**771 Closure Project
Decommissioning Operations Plan
Modification 5**

August 8, 2003

11 COMMENT RESPONSIVENESS SUMMARY

Figure 4. Building 771 First Floor Plan Demolition Concept

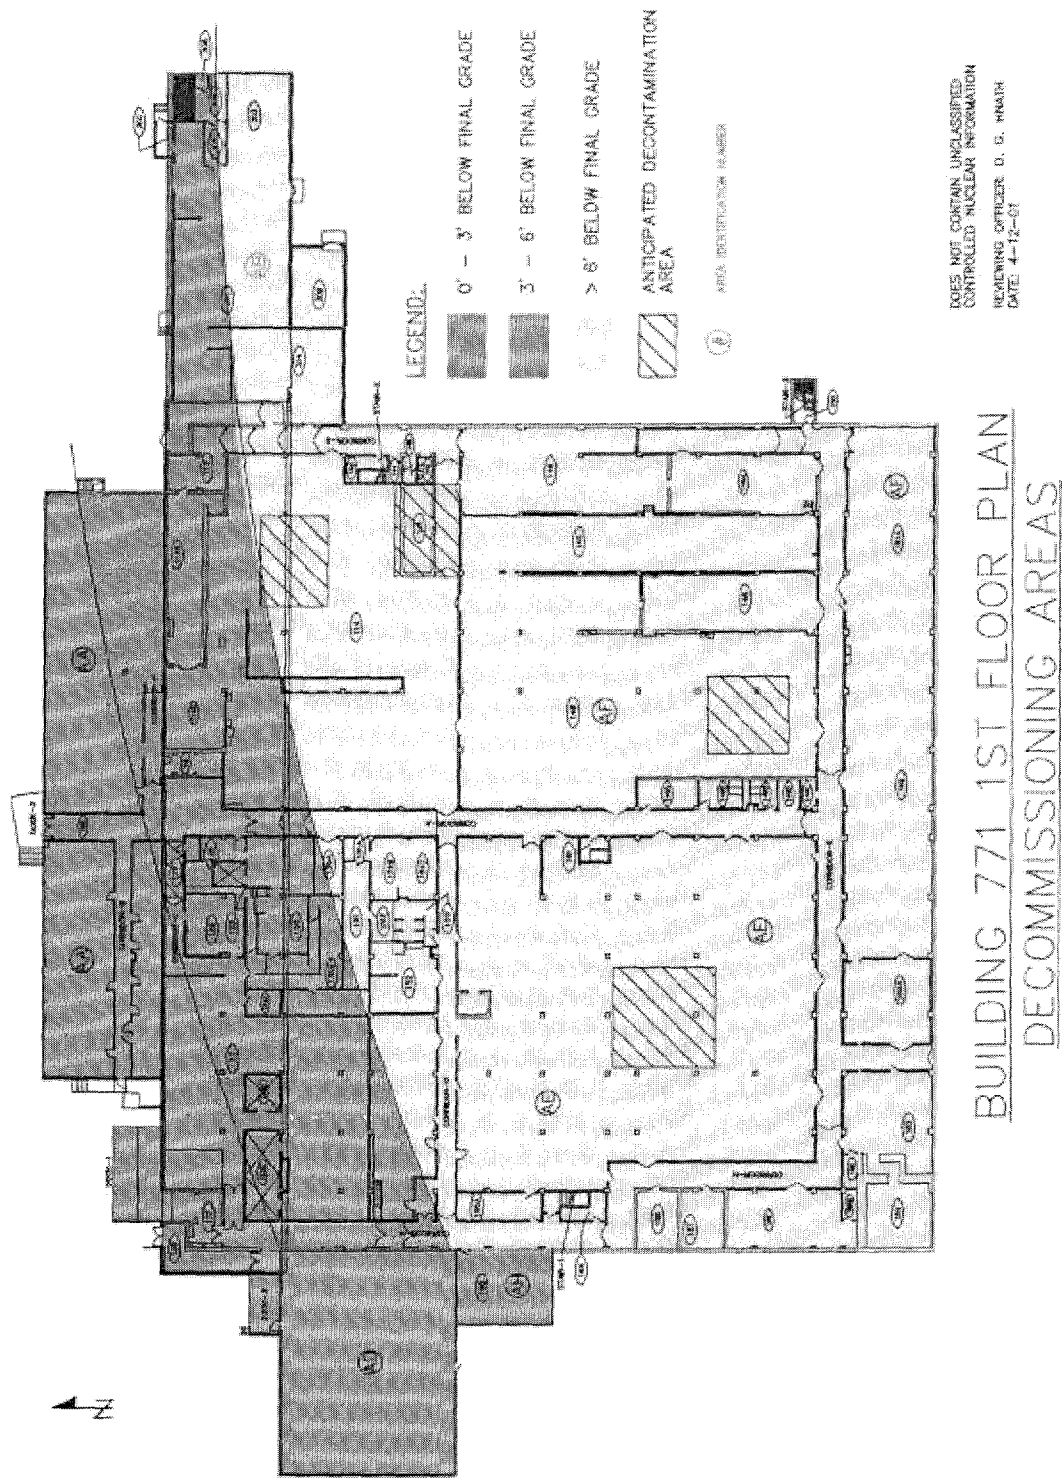
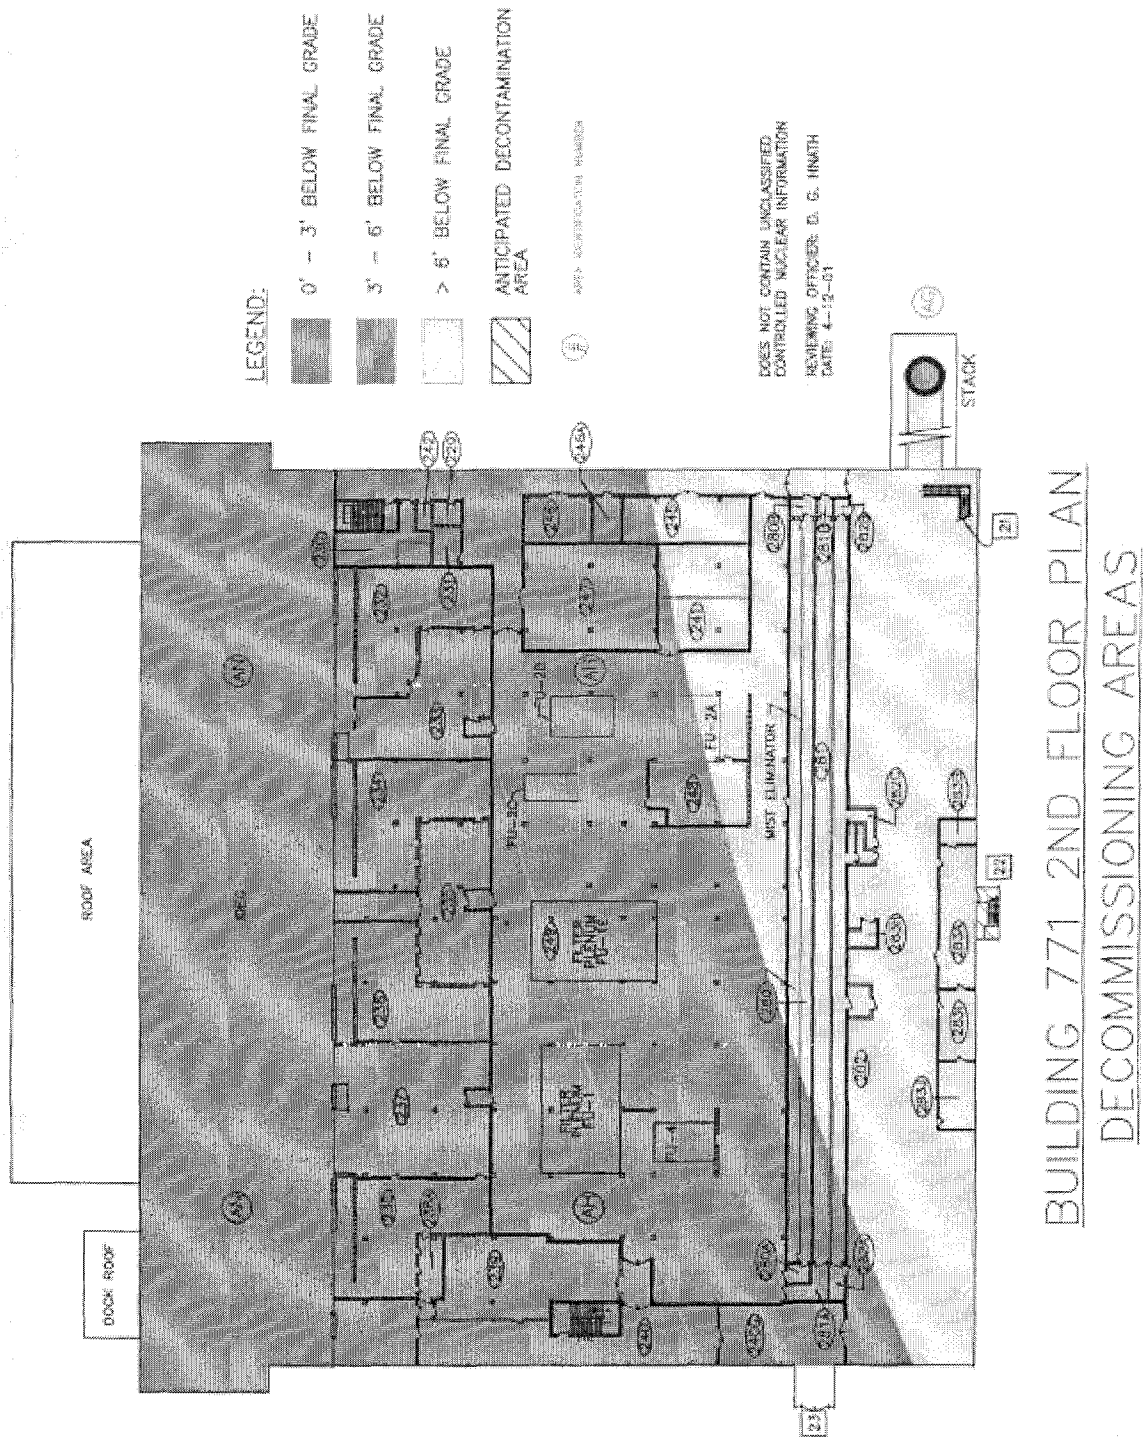
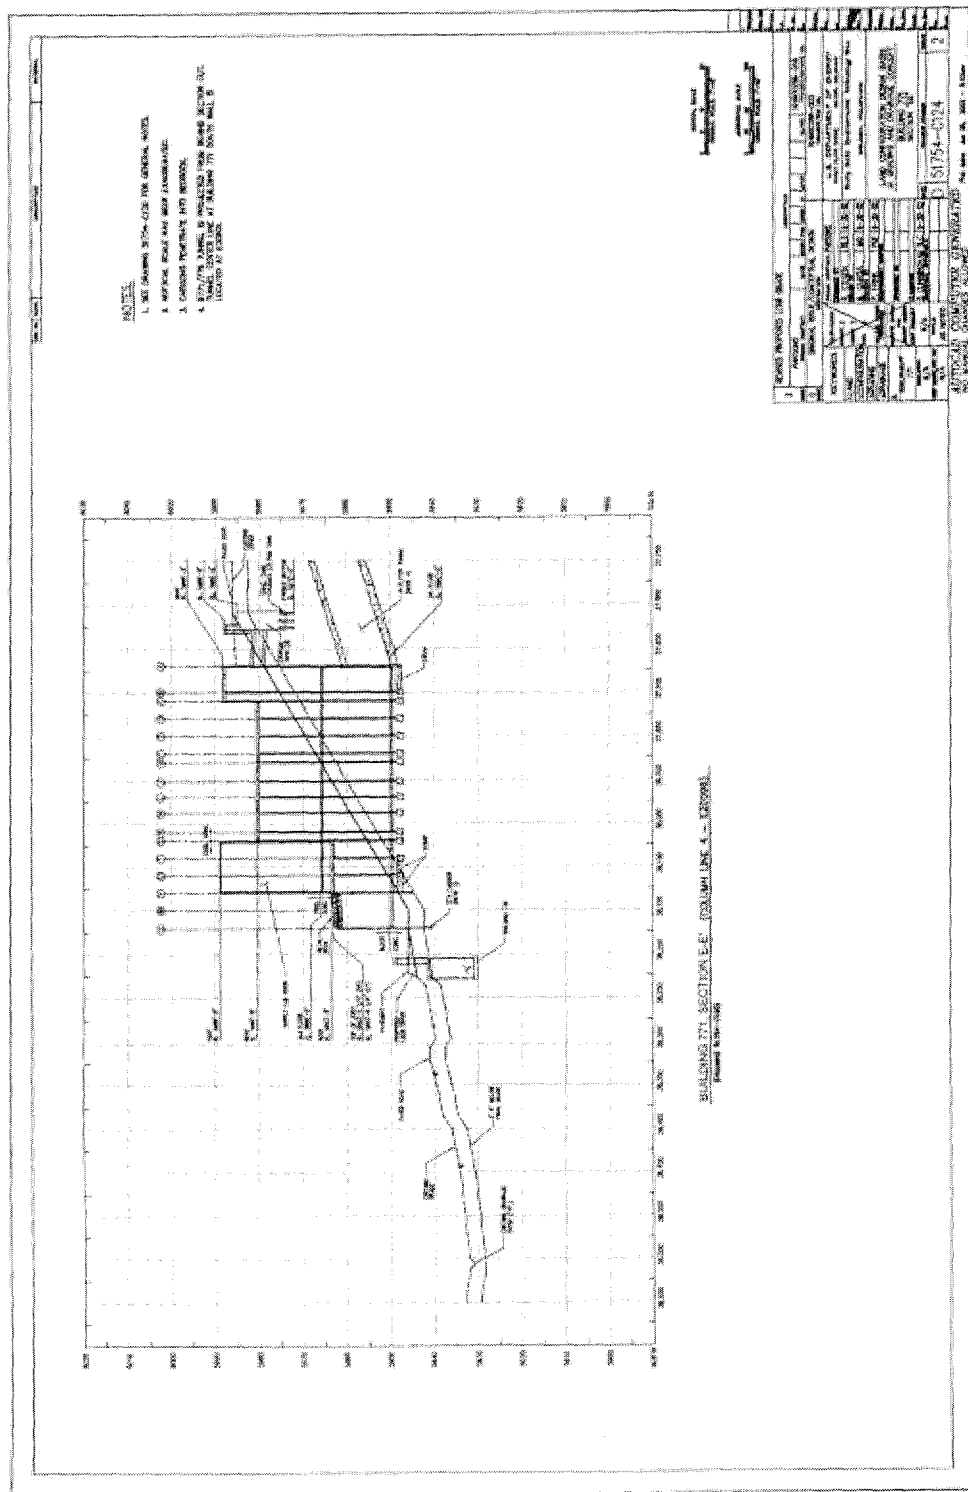
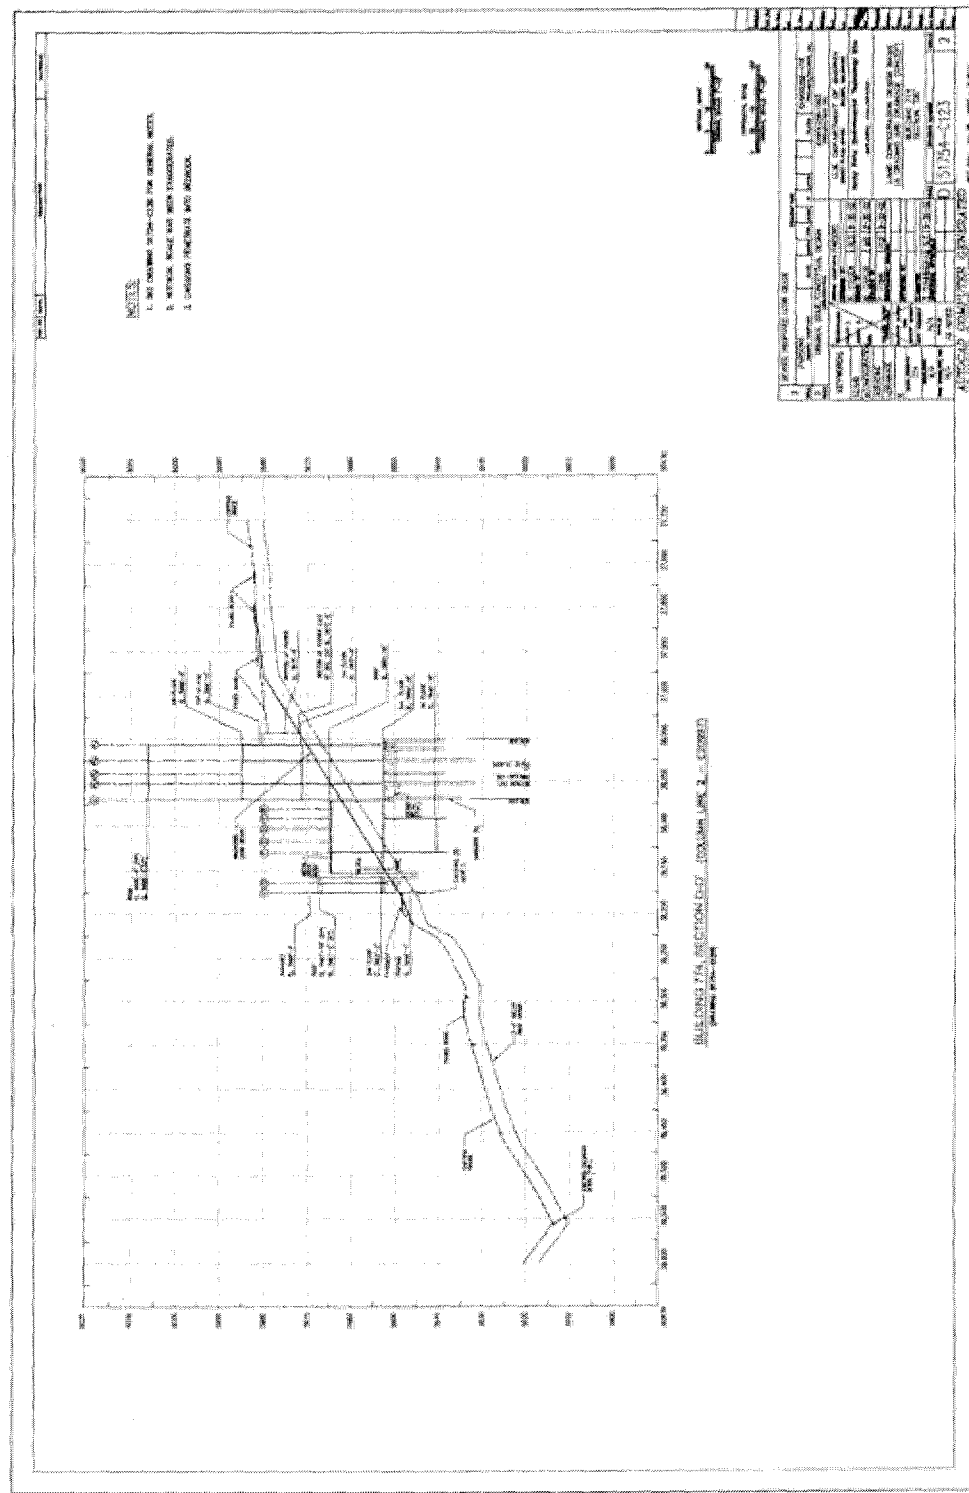
5	<p>Figures</p> <p>The text in Section 4.7.1.8 (Demolition of the Main Building 771 Structure) describes the planned three-sided configuration for the Building 771 foundation area after demolition, and states that "Figures 4 and 5 provide an aerial view of this concept." Figures 4 and 5 provide a useful aerial view, but they do not show the three-sided configuration referenced. During the Coalition staff briefings, Site representatives distributed side-view diagrams of the post-demolition condition of B771 and B774. It would be helpful to include these diagrams so that the reader has a better understanding of the depth of the buildings and how much of the structures will be demolished.</p>	<p>These figures were added to the document.</p>
